Our Ref: R/2016/1/C
File No: MP 08_0098 MOD 13

Modification Request for The Star (MP08_0098 MOD 13) – 20-80 Pyrmont Street, Pyrmont

The City of Sydney (the City) has reviewed the information provided as part of the public exhibition and **objects** to the Section 75W modification of the project approval.

Figure 1: Location of tower within the context of approved and proposed development in Darling Harbour

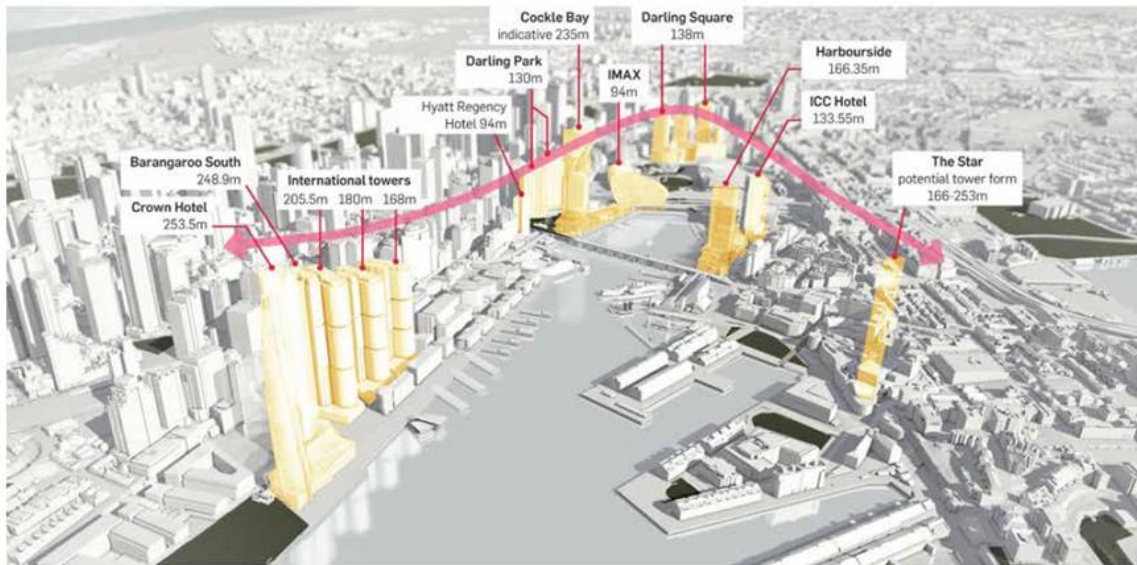
15. Figure 1 in the visual impact assessment prepared by Architectus provides a “context” to justify the tower that exists outside of Pymont. It is clear from the view assessment on Cockle Bay that there is no context of towers in the Pymont vicinity. Nor is there a proposed or approved future context of towers.

Figures from 4.2.13 of the Visual Impact Assessment by Architectus

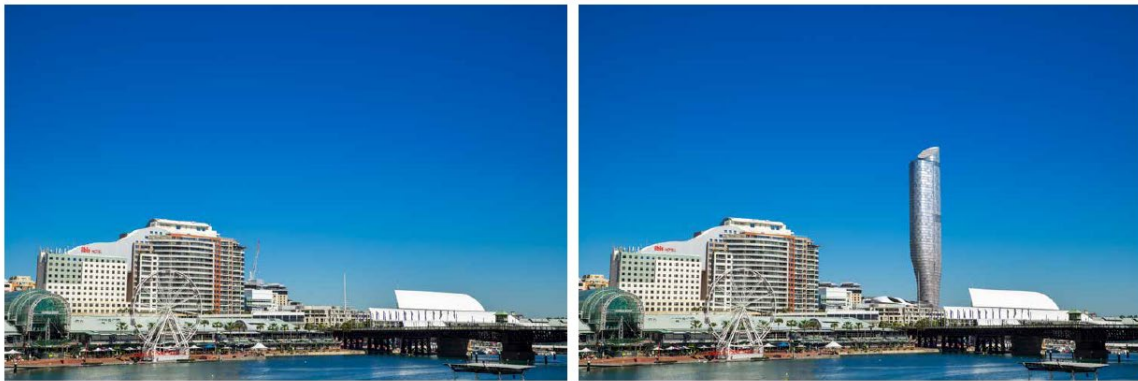
16. The tower form has a **high impact** on the views from 30 dwelling as demonstrated in the Visual Impact Assessment prepared by Architectus. The views to the city skyline and large amounts of sky which are currently enjoyed by a number of Pymont residents are replaced with a large tower form. It is argued by the applicant that this is acceptable on the basis of “view sharing”. However, the impacts are created by the proposed 237m high tower, a tower that is not anticipated by any of the controls and therefore could never be anticipated by the impacted Pymont residents. The view impacts are created by a building form that far exceeds all primary controls and community expectations based on those controls, therefore the principles of view sharing are not exhibited.

The applicant's analysis demonstrates the substantially greater impact on views and access to sky the proposed tower will have compared with the LEP envelope – shown in blue.

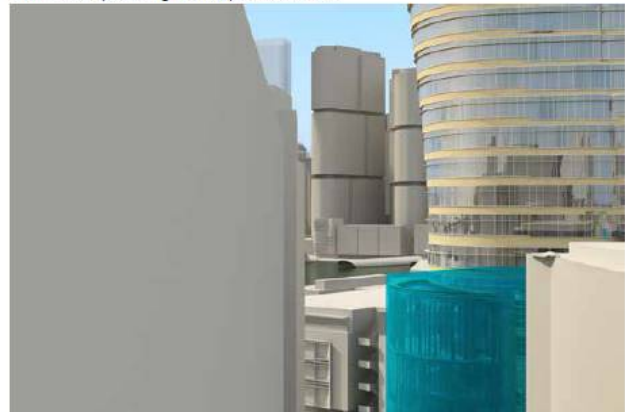
17. The Visual Impact Assessment prepared by Architectus also demonstrates that there will be a greater impact on views from the public domain than would be created by a LEP compliant scheme. This includes views from Martin Place, Glebe foreshore parks, Cockle Bay, Union Square and Pyrmont Bay Park among others.
18. The tower height results in the tower being visible in close proximity to the GPO clock tower when viewed from the east down Martin Place. The view of this key heritage landmark against an uncluttered sky has been identified as a key planning constraint in current and proposed planning for the west side of the city. This is an unacceptable heritage impact. The conclusions of this assessment are not credible given the immense scale and isolation of the project on the harbour foreshore – and with no planning framework to support the project.

19. It is important to note that while a 24mm focal length has been included in the Visual Impact Assessment, the 50mm focal length more accurately represents what a human eye sees. Therefore while the impact appears lesser on the 24mm focal length images provided, this is not what will be perceived as the actual impact. In addition to the above, there are a number of other key concerns that are required to be addressed and/or clarified. These are found within **Attachment A** to this letter.
